**Southern Nuclear Operating Company
Vogtle Electric Generating Plant Units 3 and 4
Revision to License Amendment Request:
Technical Specification 3.3.13 for Main Control Room Emergency Habitability System
(VES) Instrumentation Applicability Change and Include Undervoltage Actuation
(LAR-20-003R1)**

**Revision to License Amendment Request:
Technical Specification 3.3.13 for Main Control Room Emergency Habitability System
(VES) Instrumentation Applicability Change and Include Undervoltage Actuation
(LAR-20-003R1)**

**ND-20-0725
Enclosure 5**

**Proposed Changes to Licensing Basis Documents
(LAR-20-003R1)**

Updated Final Safety Analysis Report (UFSAR) Figure 7.2-1 (Sheet 13 of 21)

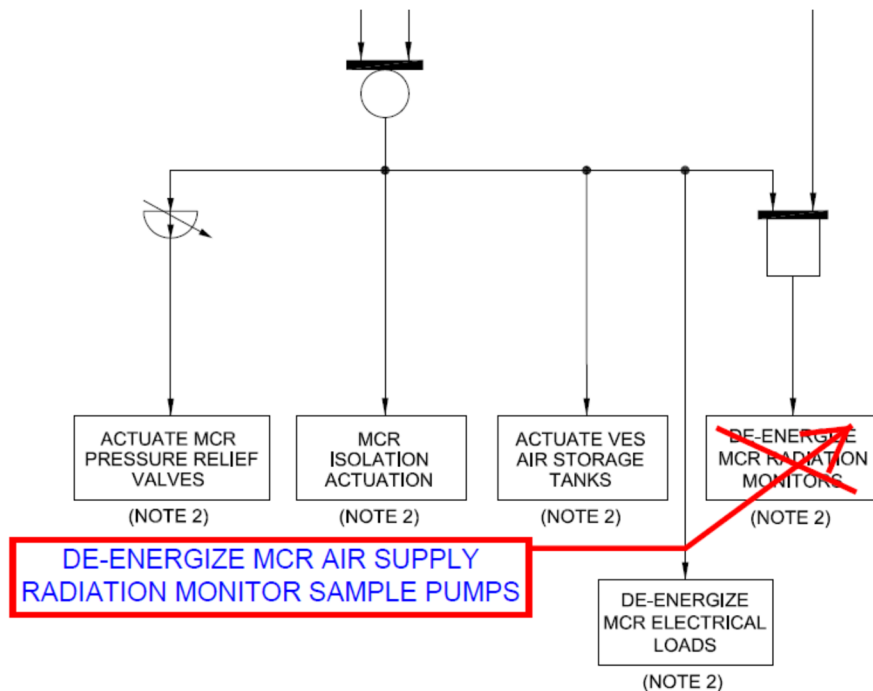
UFSAR Figure 7.2-1 (Sheet 13 of 21) is updated to change the output description “DE-ENERGIZE MCR RADIATION MONITORS” to “DE-ENERGIZE MCR AIR SUPPLY RADIATION MONITOR SAMPLE PUMPS”, as the undervoltage to the Class 1E battery chargers Function de-energizes the MCR radiation monitor sample pumps.

- UFSAR Figure 7.2-1 (Sheet 13 of 21) change the functional block “DE-ENERGIZE MCR RADIATION MONITORS” to “DE-ENERGIZE MCR AIR SUPPLY RADIATION MONITOR SAMPLE PUMPS.”
